Subject: Response to DMS comments on the Year 3 Monitoring Report Review for the Upper Silver Creek Stream and Wetland Restoration Project; Catawba River Basin - CU# 03050101; Burke County, North Carolina; NCEEP Project # 94645; Contract No. 003270

Upper Silver Creek Restoration Project Year 3 Monitoring Report

Burke County, North Carolina
NCDMS Project ID Number – 94645

Figure 2 - Overview
Current Conditions Plan View
Monitoring Year 3
Upper Silver Creek Site

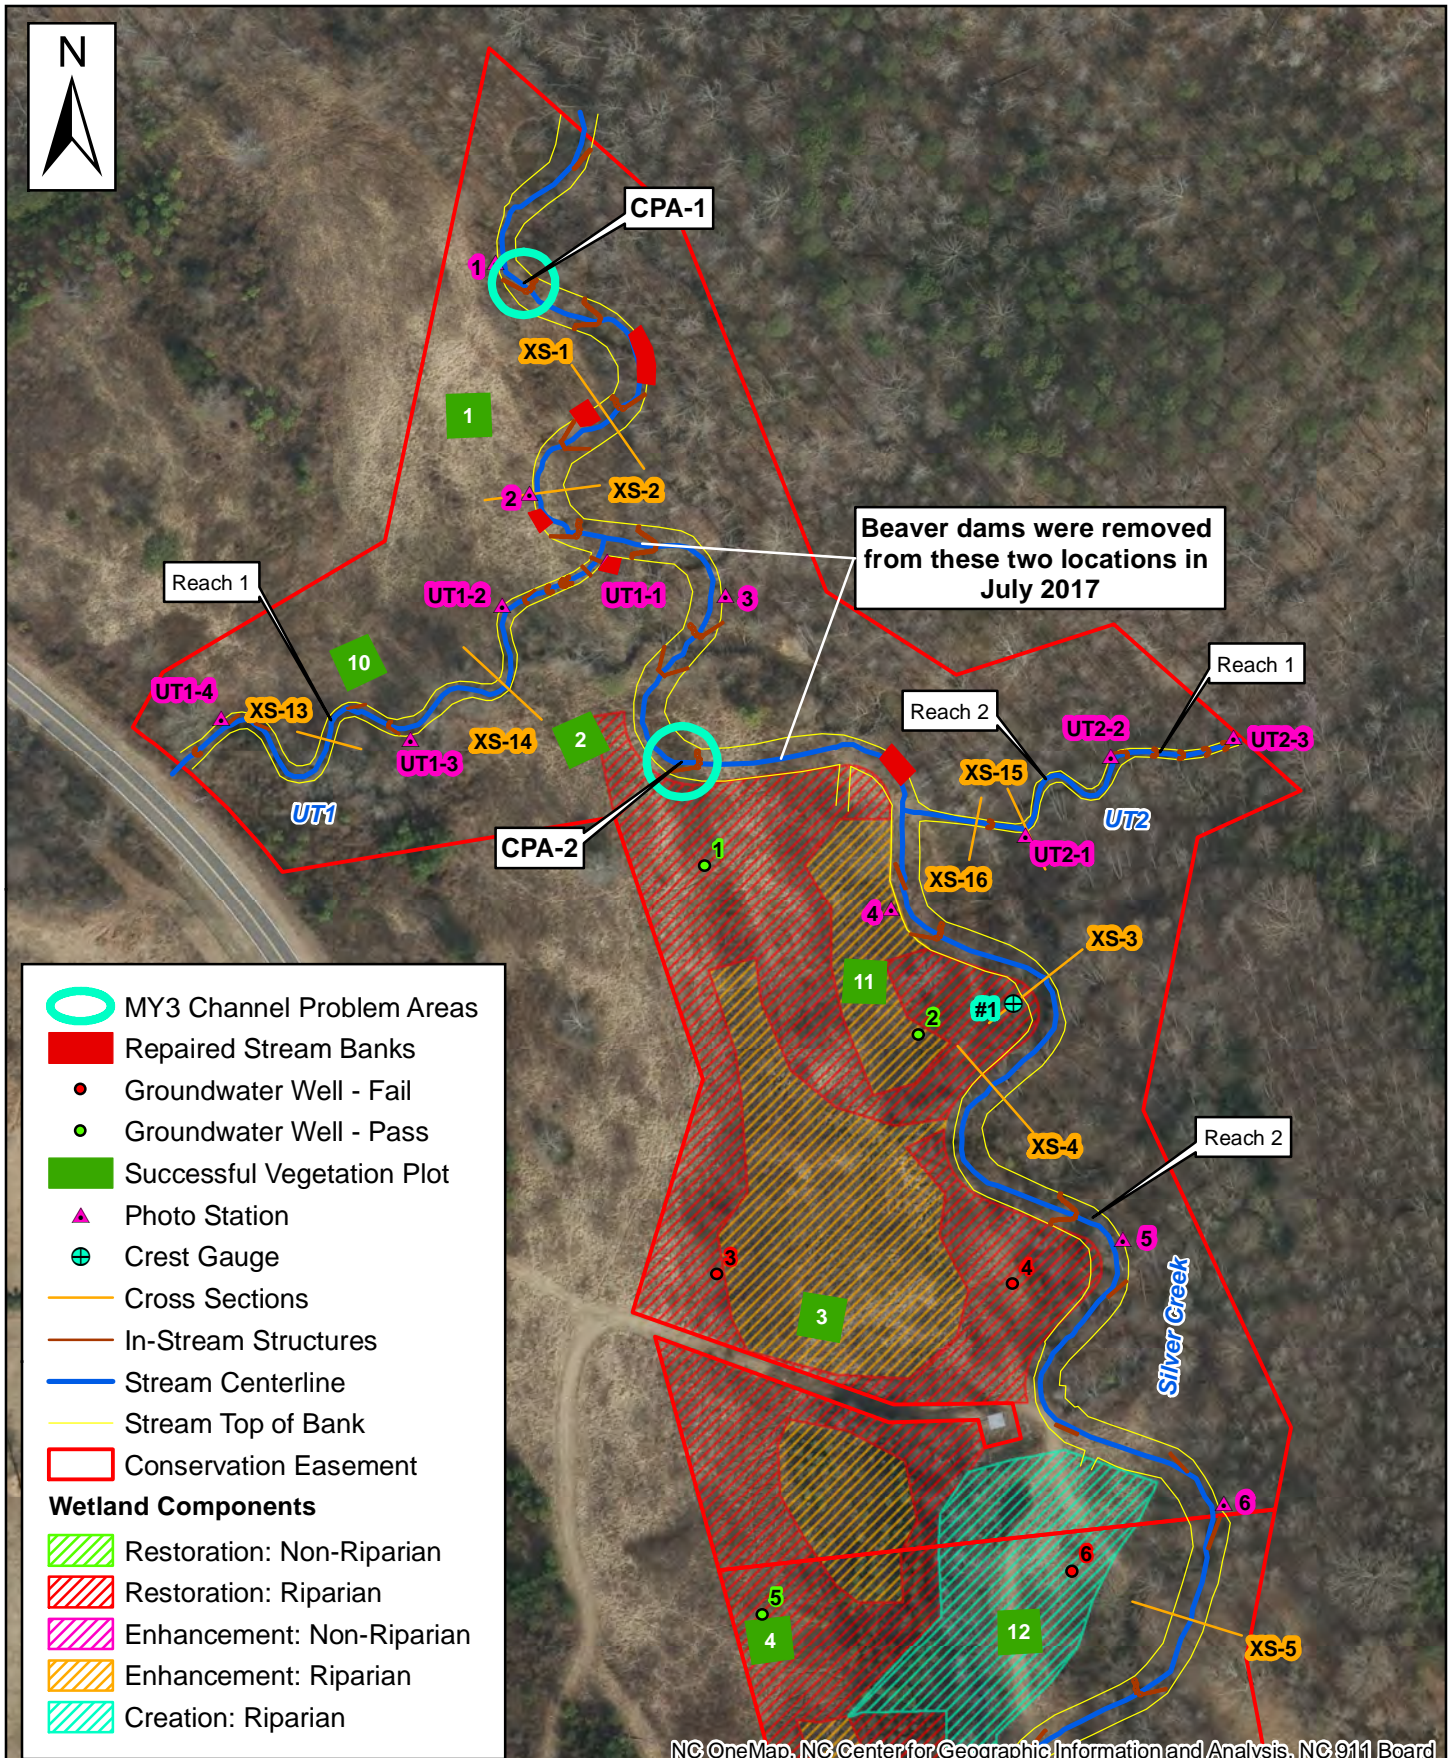
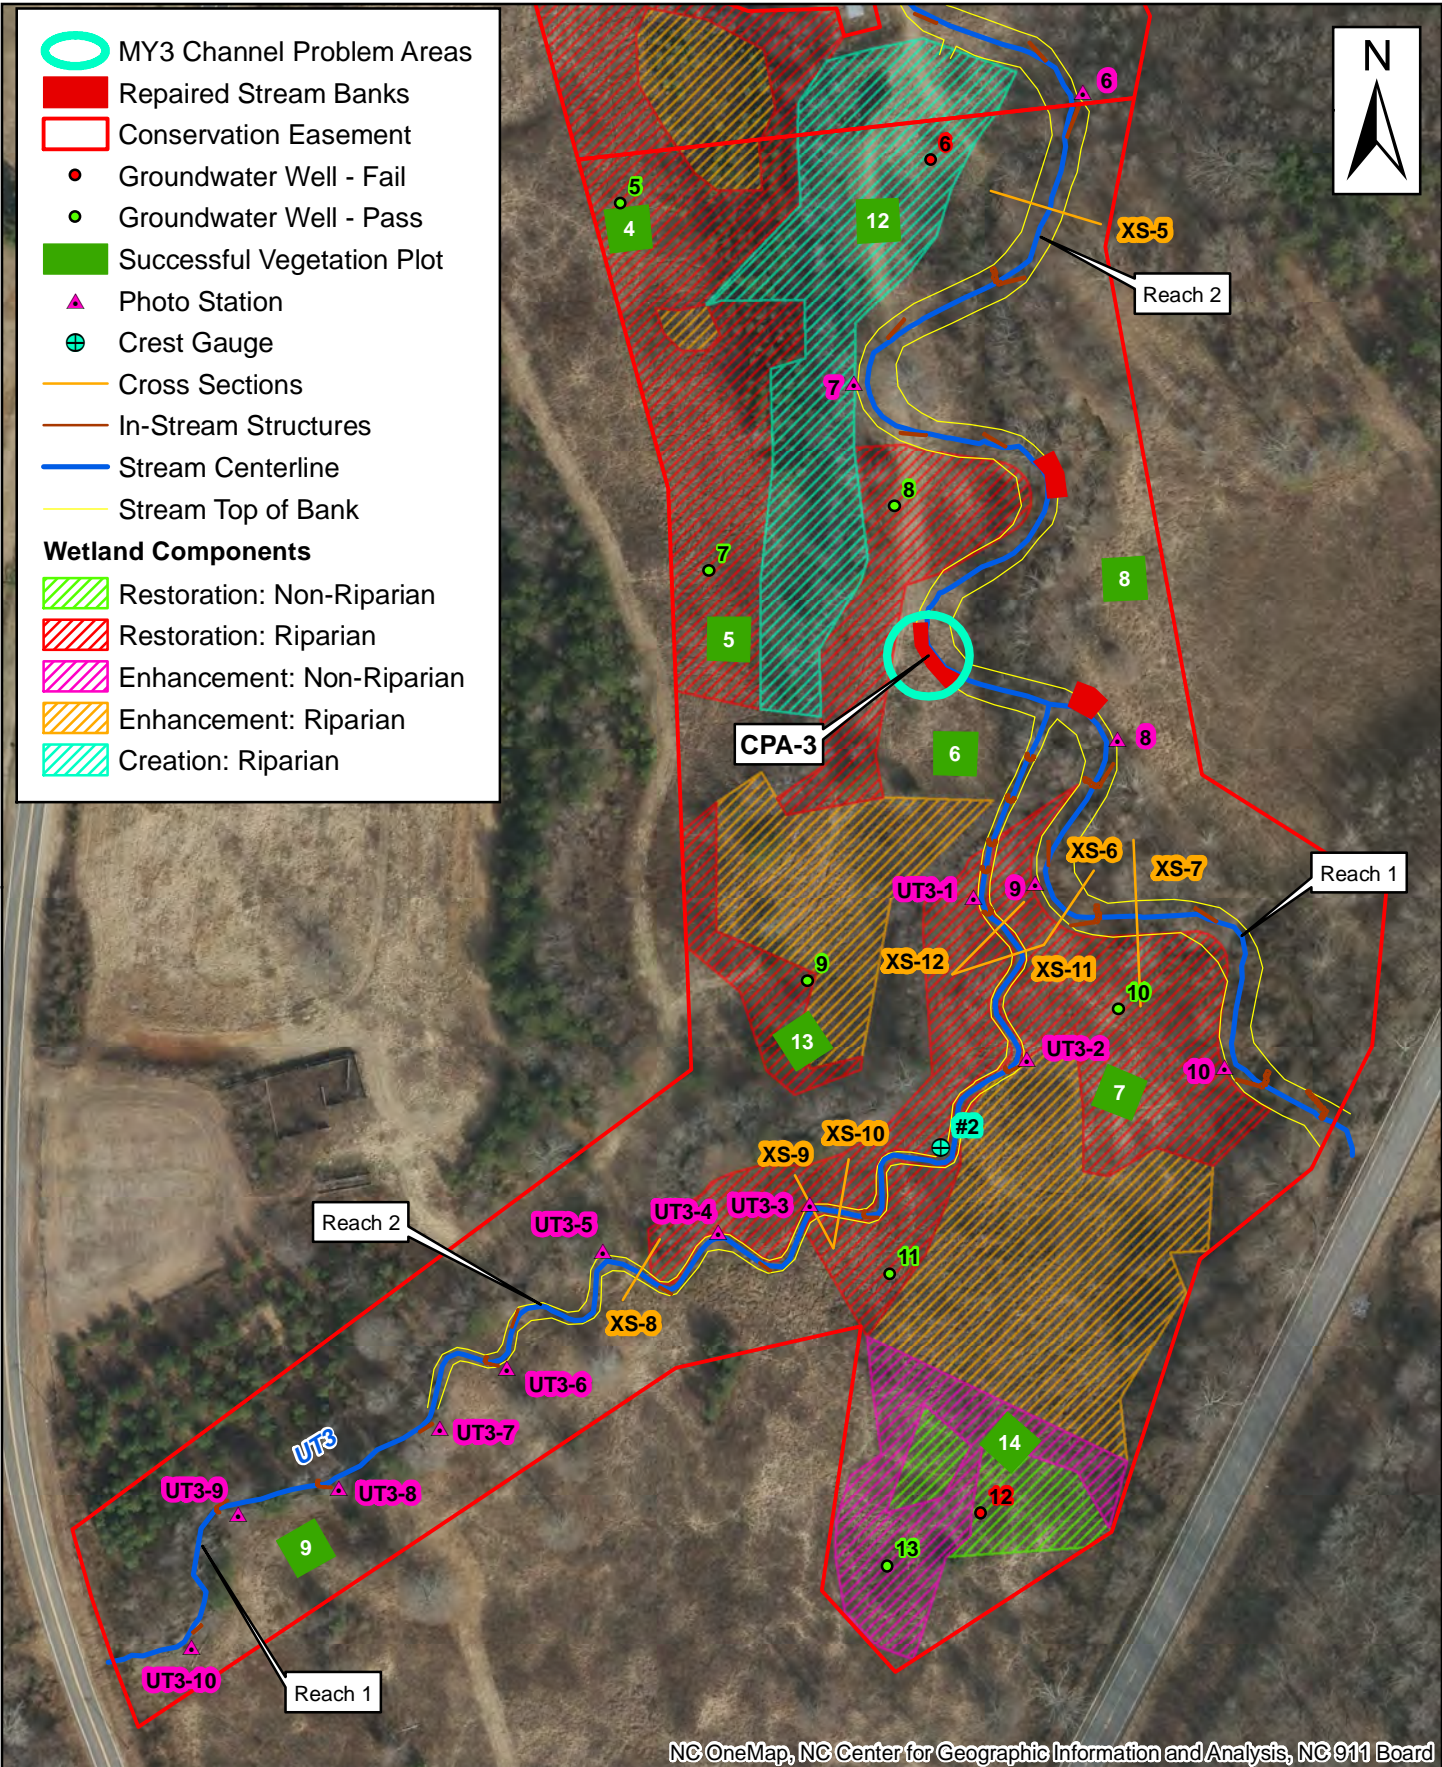
- Modify either CCPV to show wetland components (R, E, Creation, riparian/non-riparian) or add *well* locations to Figure 3. The locations of the wells in relation to wetland component is valuable information for agency reviewers.
 - *Both the CCPV and Figure 3 were modified to show both the wetland components and well locations on the site. This will make it easier to draw comparisons between the two maps in the future.*

Figure 4. Upper Silver Creek - Vegetation Plot Photos, DMS Project #94645

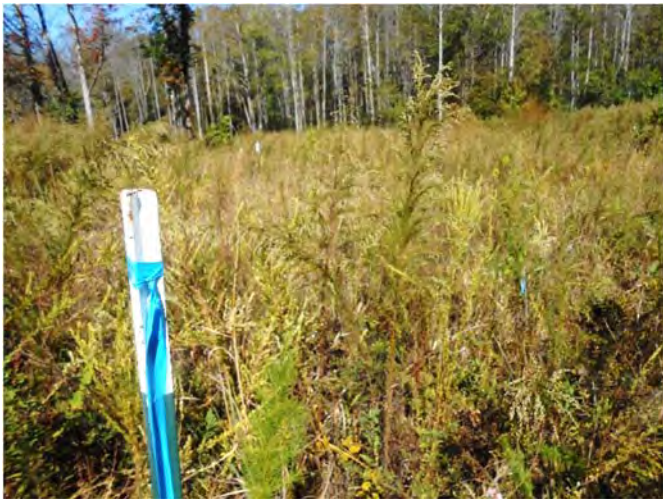
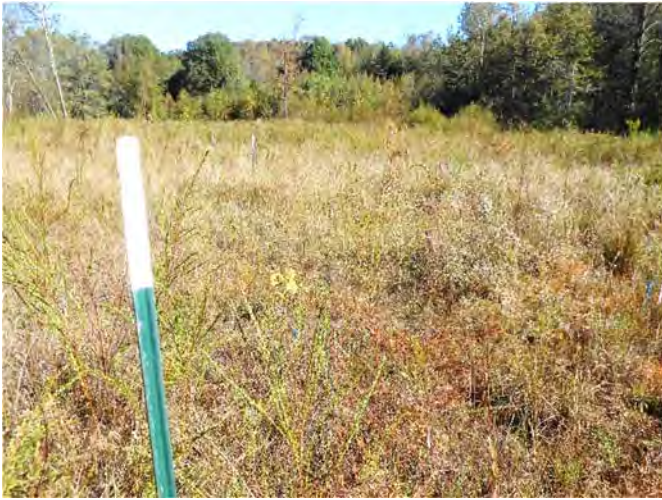
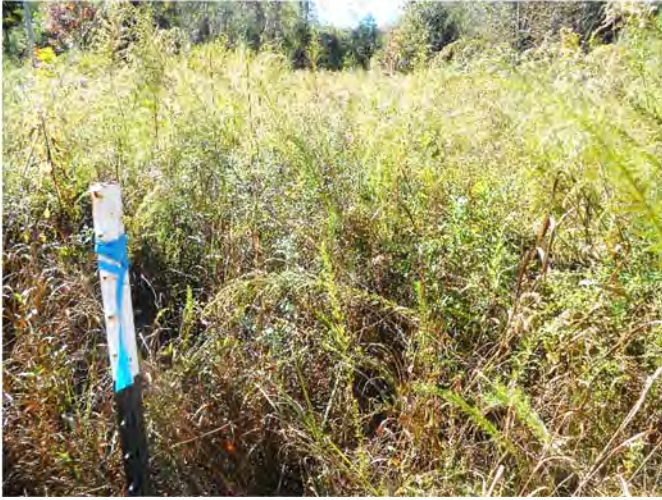
- Currently labeled as Figure 3 in hard copy. Should be Figure 4 according to Table of Contents. It is correctly labeled in PDF.
 - *The Vegetation Plot Photos have been labeled Figure 4 in the report as well as the Table of Contents.*
